HDS - BULVERDE, UNIT 1
PRELIMINARY OVERALL DEVELOPMENT PLAN
BEXAR COUNTY SAN ANTONIO, TEXAS

Re: HDS - Bulverde

POADP # 607

P.O.A.D.P REVIEW

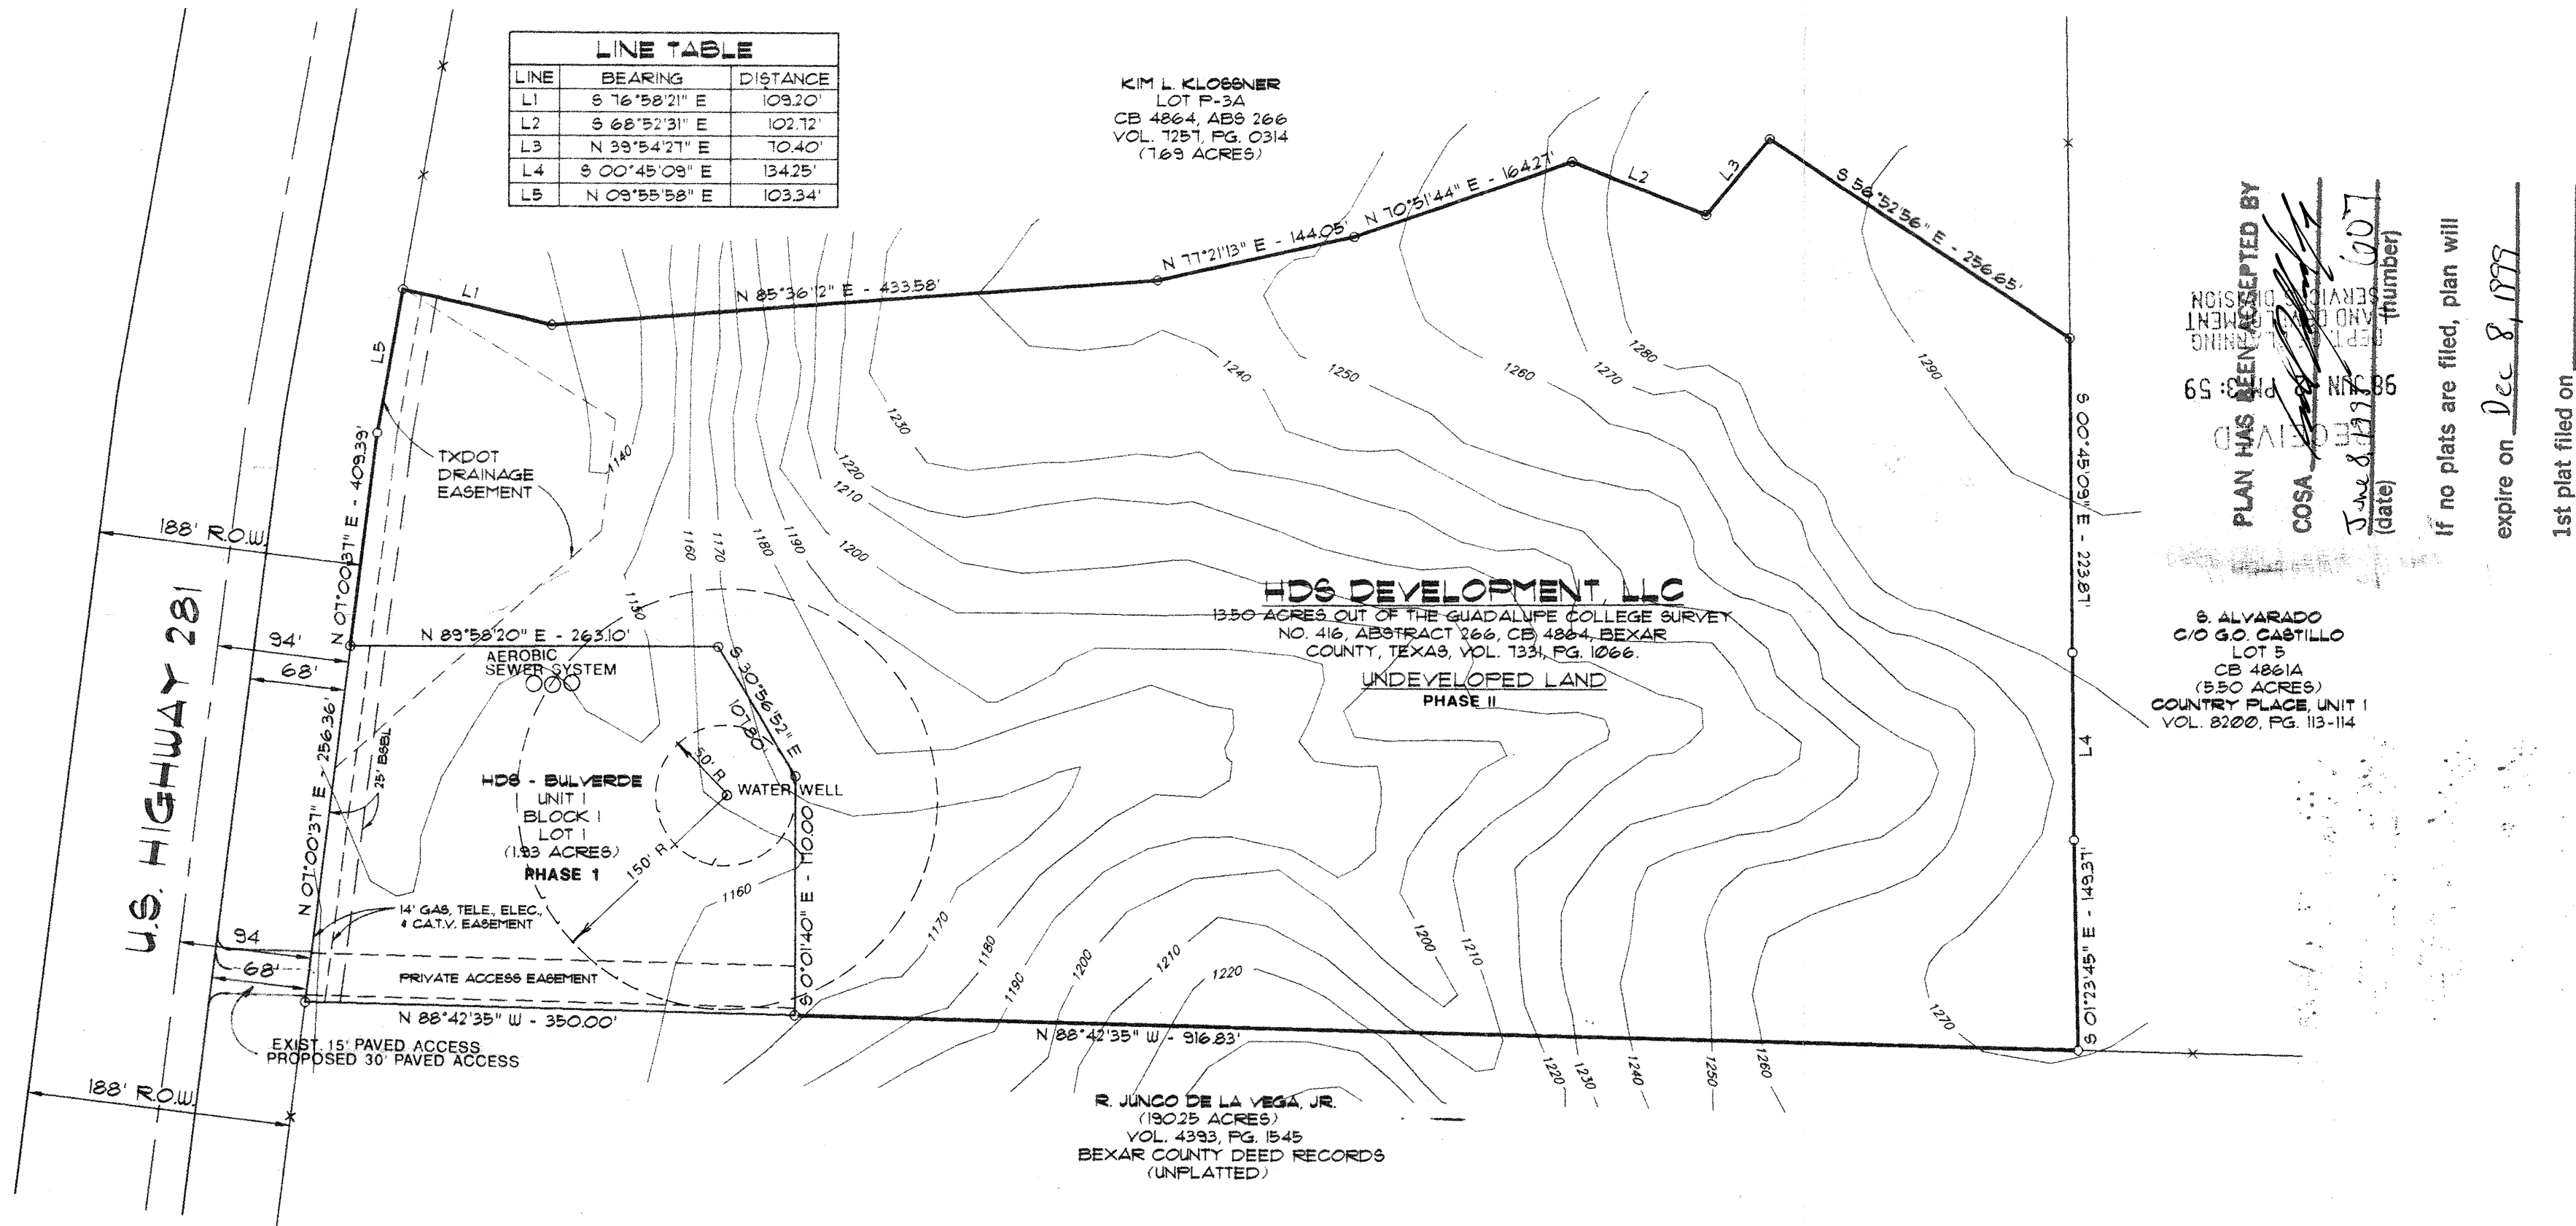
- Based on the topography, a Flood Plain Study and drainage review will probably be required during the platting process.
- In consideration of public safety and convenience, excessive grades by reason of topography should be avoided in street layouts and arrangement.
- Access and R.O.W. issues along State facilities will need to be resolved with the Texas Department of Transportation. For information about these requirements you can contact TXDOT at 615-5814.
- This development will need to comply with tree preservation ordinance #85262. For information about these requirements you can contact Building Inspections at 207-7102.
- It will be expected that you will plat all of the property depicted in your POADP, to include: floodpains, drainage areas and open space.
- I would encourage you to work closely with the school district, so that they can plan accordingly.

Future expansion of US 281 will require a minimum of 150 feet of additional ROW at this location. Therefore we request that all planned development be setback a minimum distance of 175 feet.

Locations of access points to US 281 from this property shall be as directed by "Regulations For Access Driveways to State Highways". No access to this property will be permitted within the existing TxDOT drainage easement.

ADDITIONAL COMMENTS: There are two existing temporary median crossovers on US 281 between Bulverde Road and Borgfeld Road. No additional median crossovers will be permitted within these limits, and the existing median crossovers will not be relocated. Future expansion plans for US 281 will include grade separations at both Bulverde Road and Borgfeld. All temporary median crossovers will be removed at the time these grade separations are constructed.

Comments: Drainage easements will be addressed
during the platting process.

- need new application
- need \$370.00
- need at least 2 phases
- show correct acreage
